MISSOULA COUNTY

BCC 2018-077
March 28, 2018

Re: Draft HHRA OU2 and OU3, BERA OU2 and OU3

1978 photo showing buried drum

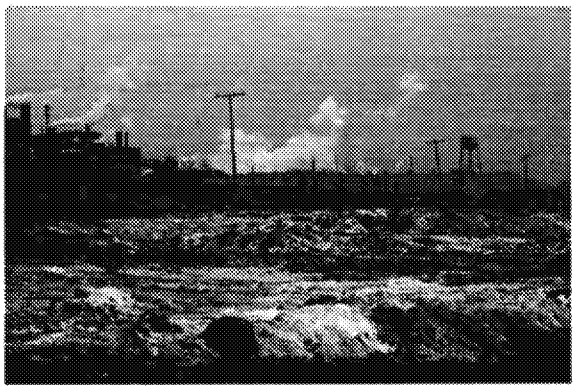
Photos from DEQ files and photos provided by past workers show that drums were buried in these dumps in 1978 and 1992. This has not yet been evaluated.

A large flood has the potential to erode 53 years of accumulation of sludge, ash and industrial waste that has yet to be properly characterized. These photos are evidence of the materials that may be currently affecting groundwater and are certainly vulnerable to floods.
